**VOLUME I
FINAL**

Environmental Impact Report/
Environmental Impact Statement (EIR/EIS)
for the San Dieguito Wetland Restoration Project

September 2000

Volume I consists of the conclusions of the Final EIR/EIS on the San Dieguito Wetland Restoration Project, the comments that were received on the Draft EIR/EIS that was circulated for public review, and the responses to those comments. Each substantive comment was numbered, and the responses contain corresponding numbers. The comments and responses are coded according to the type of commentor; i.e., comments from federal agencies begin with "F," those from state agencies begin with "S," those from local agencies begin with "L," those from organizations begin with "O," and those from individuals begin with "I." Comments from the public hearing on the Draft EIR/EIS are coded "PH."

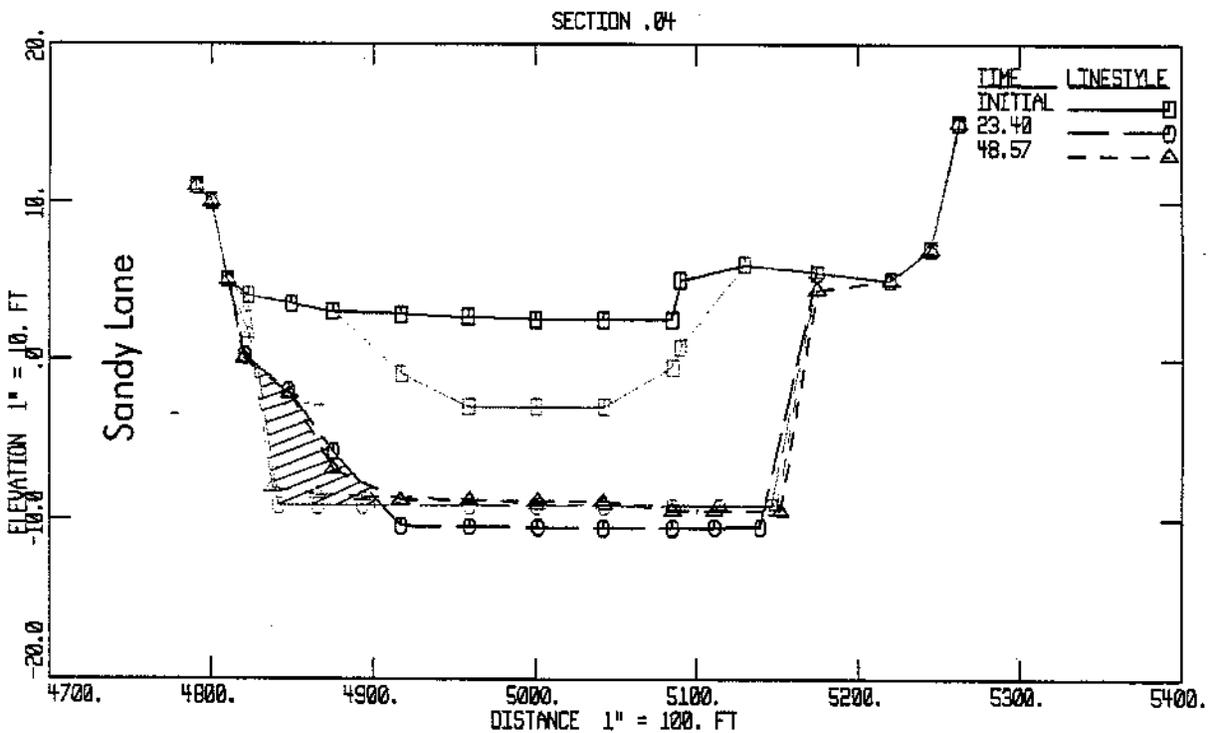
Cross-section 0.04 is near the end of Sandy Lane, and crosses the beach area intersecting Camino Del Mar. Under the existing conditions there is slightly deeper scour within the San Dieguito River near the center of the channel. The proposed conditions shows that the maximum scour in the river is less than the existing conditions near the center, but the scour adjacent to Sandy Lane has increased due to the channel widening.

This cross-section is looking downstream and it shows the differences in scour near Sandy Lane. The blue colored area represents the proposed project. The black colored area represents the existing condition. The crosshatched area shows additional scour at the Sandy Lane slope revetment. Since there is a significant increase in scour near the riprap revetment protecting the homes along Sandy Lane, the San Dieguito Wetland Restoration Project must provide slope protection for this area to mitigate for this scour.

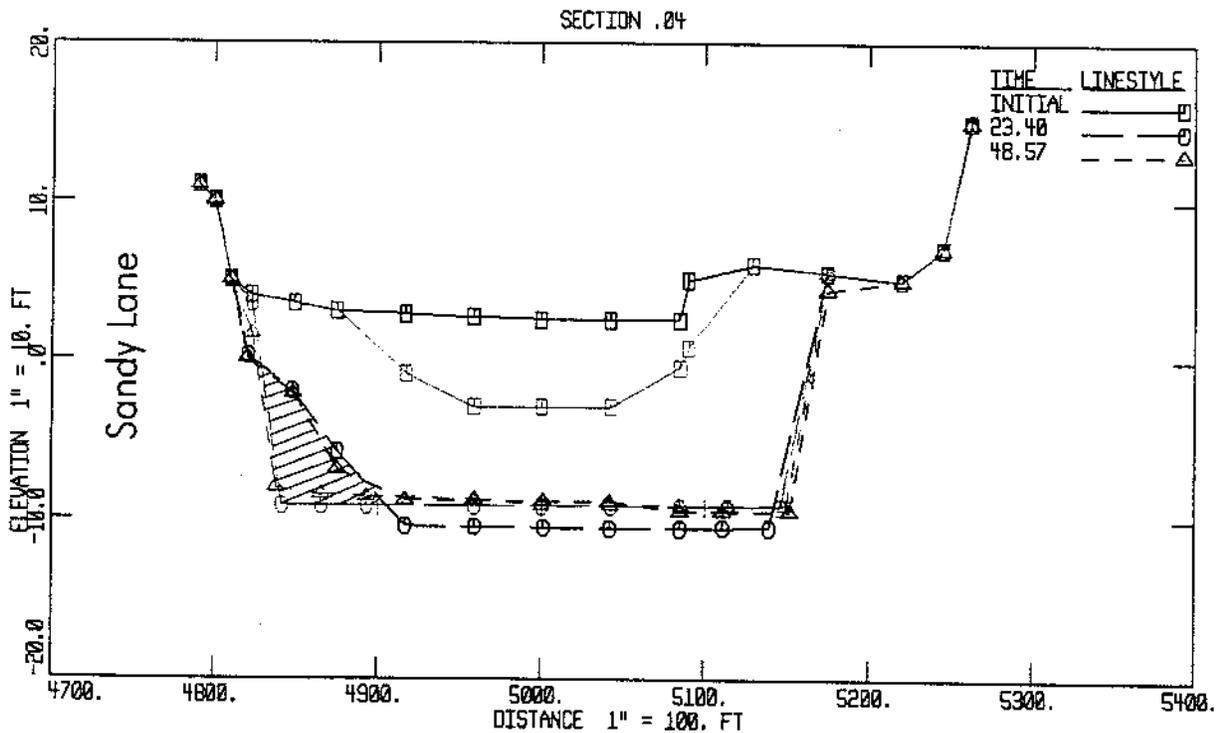
Cross-section 0.04 is near the end of Sandy Lane, and crosses the beach area intersecting Camino Del Mar. Under the existing conditions there is slightly deeper scour within the San Dieguito River near the center of the channel. The proposed conditions shows that the maximum scour in the river is less than the existing conditions near the center, but the scour adjacent to Sandy Lane has increased due to the channel widening.

This cross-section is looking downstream and it shows the differences in scour near Sandy Lane. The blue colored area represents the proposed project. The black colored area represents the existing condition. The crosshatched area shows additional scour at the Sandy Lane slope revetment. Since there is a significant increase in scour near the riprap revetment protecting the homes along Sandy Lane, the San Dieguito Wetland Restoration Project must provide slope protection for this area to mitigate for this scour.

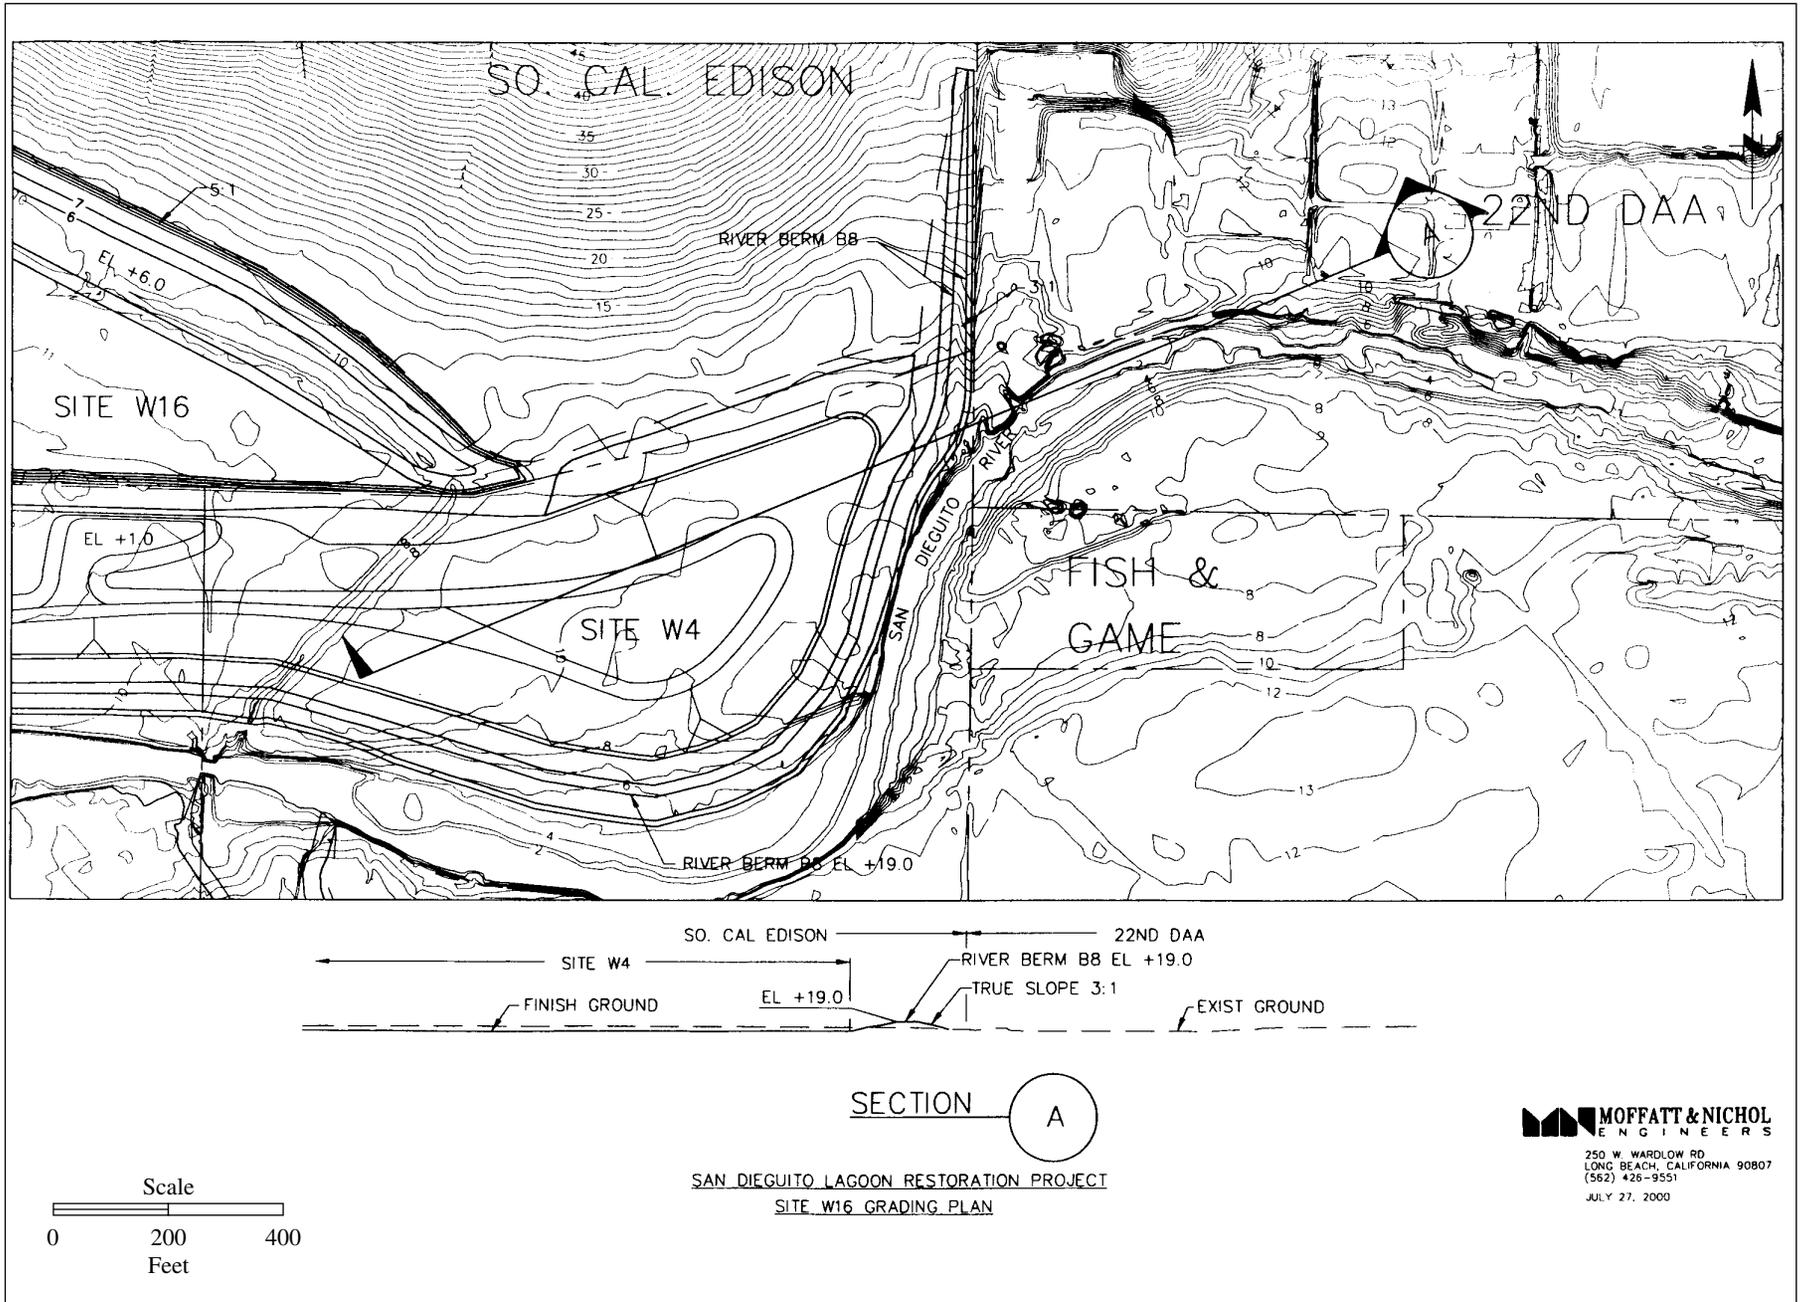
- S4-7** The cross-sections shown in Figure 2.3.1-5 do not illustrate the proposed height of the berm relative to the existing elevation of the adjacent Horsepark property. Notwithstanding, all of the preceding comments apply to a berm of any height along Horsepark's western boundary. The EIR/EIS should be revised to identify and address alternatives that eliminate the north-south berm adjacent to Horsepark, as the District had

S4-7 The proposed height of the berm relative to the existing elevations is illustrated in Figure S4-5.1. No alternatives to the use of the berm in this location are proposed, as no significant, unmitigated impacts associated with the berm have been identified.
